04.28.2014 SECOND RECOMMENDATION PACKAGE
3601 GREENWOOD AVE. N. | FREMONT GREEN | DPD PROJECT # 3015117

PROJECT HISTORY

INITIAL RECOMMENDATION MEETING DIRECTION		RESPONSE
<p><u>CORNER</u></p> <p>Several of these questions were followed up during the Board’s deliberations. First was the alignment of the residential floor plans above the first floor and the effect that placing bedrooms at the corner had on the design. In effect, the building “turned its back” on the neighborhood and provided a situation lacking a desirable “eyes on the street.” The units needed greater openings at the corner and the living rooms belonged there, not bedrooms. The corner was thought to be the “weakest part” of the overall design of the building. The board would expect to see a stronger street presence at the southeast corner of the building, at the upper residential floors. This would appear to necessitate providing living area at the corner units.</p>		<p>Response: The design team agree with board’s recommendation, and revised the floor plans so living rooms are located at the southeast corner. The exterior of the building has been modified to provide strong corner delineation with large openings an

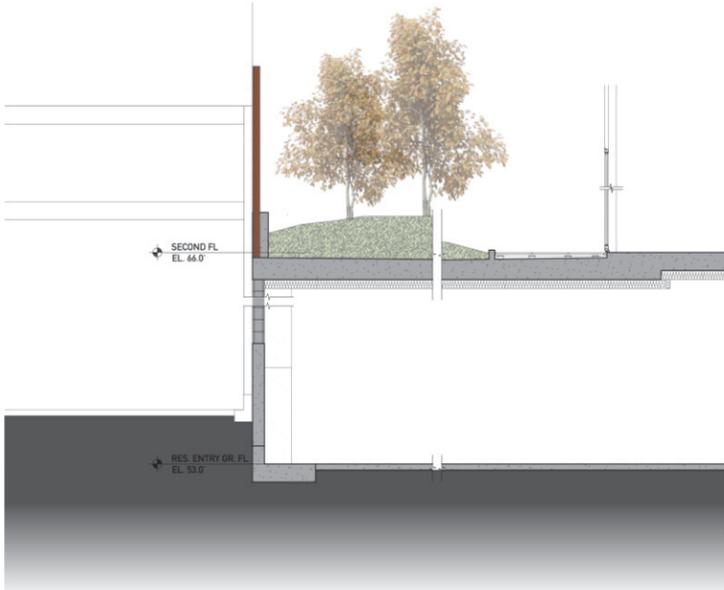
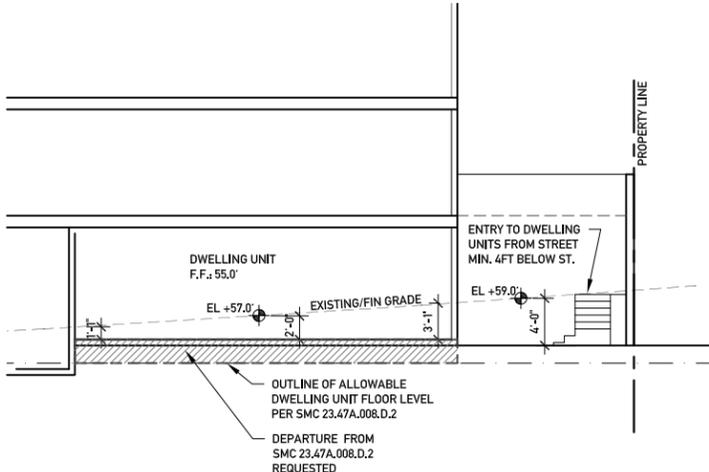
<p><u>GROUND FLOOR</u></p> <p>The vertical brick pilasters on the ground-floor, commercial level were at odds with the pronounced horizontality of the upper floors. Brick did not appear to be the proper choice in materials; the Board found the rationalization regarding contextual considerations of Fremont brick usage to be weak; the choice of brick struck the Board as being “too arbitrary.” Wood or concrete might be preferable as materials. The commercial frontage, it was suggested, could be all glass, with structural elements interior to the glass, or the entire lower level facade could respond to other elements of the Fremont look. It should echo the horizontality of the upper floors in some way. The perspective showing the residential entry and the bike rack is “anywhere USA”; it falls with a thud.</p>		<p>Response: The brick has been removed. Instead, the pilasters are proposed to be in concrete with 1’ft horizontal score lines to continue the horizontality of the rest of the building. The storefront also has been modified to add more horizontal mullions.</p>

<p><u>BLANK WEST WALL</u></p> <p>The Board thought that the blank wall on the west facade needed further attention. While unavoidable, the blank wall along the west facade still requires design treatment to reduce pedestrian discomfort and, since highly visible, to increase visual interest along the street scape. The Board was not convinced that the proposed treatment had exhausted the possibilities for a design that promoted pedestrian comfort and visible interest. Although the possibilities may be limited, there remained opportunities that needed further exploration. The EVO building, further west on N. 36th Street, was mentioned as an example of an art treatment of a highly visible blank wall.</p>		<p>Response: The west facade still continues to present challenges since there is no construction easement from the neighbor to the west. The project team is limited to what is physically possible to build only from one side of the wall. After the initial recommendation meeting, the project team redesigned the west facade so it is more integrated to the rest of the building. Per the Board’s request, the renderings show freestanding signs that are on the west neighbor’s property.</p>

N. 36TH STREET

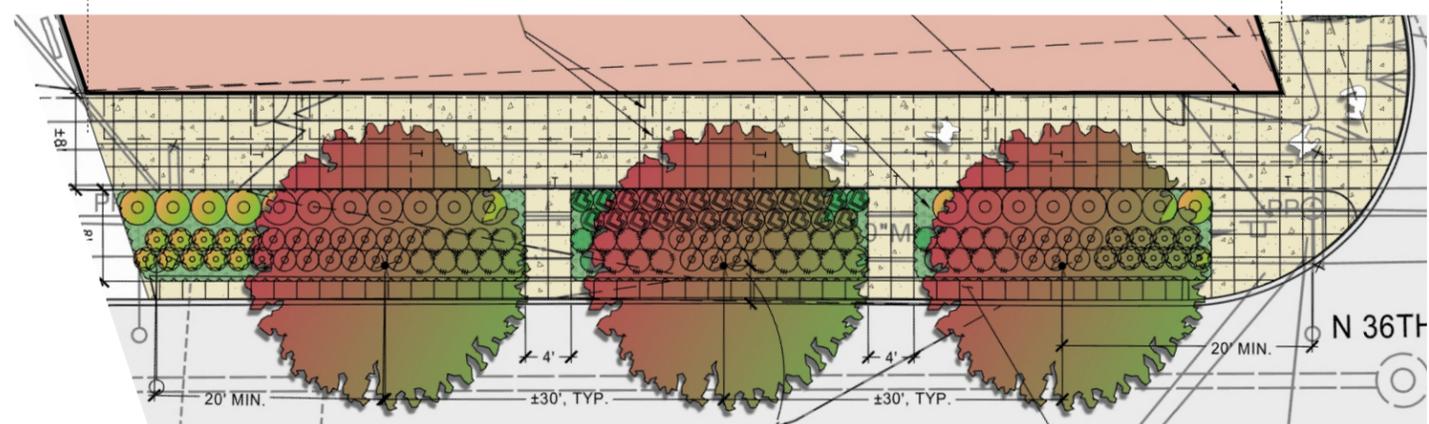
INITIAL RECOMMENDATION MEETING DIRECTION		RESPONSE
<p>DECK DESIGN</p> <p>The low level of landscaping at the western edge of the upper roof amenity space does not provide a sufficient buffer to prevent residents from obtruding themselves into the G&D outdoor serving areas. The general design of the rooftop deck lacks detail, but nonetheless is unconvincing as an attractive amenity area or well-functioning space. While the lower amenity area, open to the west, seems to provide a sufficient buffer area at the western edge, a section through the space and through the entire property to the west would be useful to aid in the board's deliberation. In addition to the landscape buffer, add some type of screening/fence atop the wall at the slice through the building, probably of wood to match the other "slices" and with greater openness as it increases in height (No powder-coated aluminum).</p> <p>Likewise, at the north property line, there seems to be an adequate landscape buffer between the proposed structure and the town homes to the north. A question was raised regarding the alignment of windows with those in the town homes. More detailed views and cross sections of the retaining wall and plantings, continuing to the floor levels of the neighboring structures to the north would be most helpful in confirming this. More details and specificity are needed. The trees at the low courtyard should be shown in section. There should be an addition of vines growing down the western portion of the north wall.</p>		<p>Response:</p> <p>More landscaping along the west edge of the roof deck is provided to buffer further from G&D outdoor serving area. This landscaped area is composed of sedum trays with taller plants to clearly demarcate that the planted area is not for walking.</p> <p>On the 2nd floor west deck/lightwell, there will be 8ft tall wood fence along with average of 30ft landscape buffer.</p> <p>Additional cross sections are provided to show the relationship between the neighboring buildings to the proposed structure.</p>

<p>DECK RAILINGS AND BIKE RACKS</p> <p>The deck railings along N. 36th Street needs further scrutiny. Why is the pronounced horizontality of the rooftop handrail not matched with a more pronounced horizontality of the hand rail at the third floor? Why powder-coated aluminum railings off the shelf when architectural consistence would suggest a more industrial or other look?</p> <p>There should be short-term bike parking easily available for patrons of the commercial uses.</p>		<p>Response:</p> <p>The third floor railing now has matching railing as the roof. It will have 18" tall railing with perforated sheet metal above short parapet.</p> <p>Short-term bike parking will be provided at the place shown in the rendering, and on the plating strip along N 36th street, pending approval from SDOT.</p>
<p>DEPARTURES</p> <p>A departure was requested from SMC 23.47A.008.D.2, which requires the floor of a dwelling unit locate along the street level, street-facing facade to be at least 4 feet above or below sidewalk grade, or set back at least 10 feet from the sidewalk. As they had at the EDG meeting, the board indicated that they thought the departure was a reasonable request. The actual recommendation by the Board for granting this request must await the return of the proposal to the Board for a second recommendation meeting and would depend upon the applicant's responses to the Board's guidance given at the interim recommendation meeting and the compatibility of the forthcoming with the Design Review Guidelines.</p>		<p>Response:</p> <p>The design guideline A-6 (old guideline) Transition Between Residential and Street acknowledges that privacy and security are important issues for ground-level housing. The entry to both ground level units are 4ft below sidewalk, and will have security fence to clearly demarcate the line between public and private. The windows facing street are short so they let light in while minimizing the visibility from the street.</p> <p>The new design guideline PL3.A.1.d & PL3.B.2 call for transition elements and space, as well as appropriately scaled and detailed entry that offer privacy, safety and security for building occupants. The gated low fence that leads to common patio provides necessary security and safety for the occupants, and clearly delineates public/private threshold.</p>

CONSISTENT RAILING THROUGHOUT

STRONGER CORNER PRESENCE

EXPOSED CONCRETE WITH HORIZONTAL SCORE LINES

HORIZONTAL STOREFRONT AND BASE
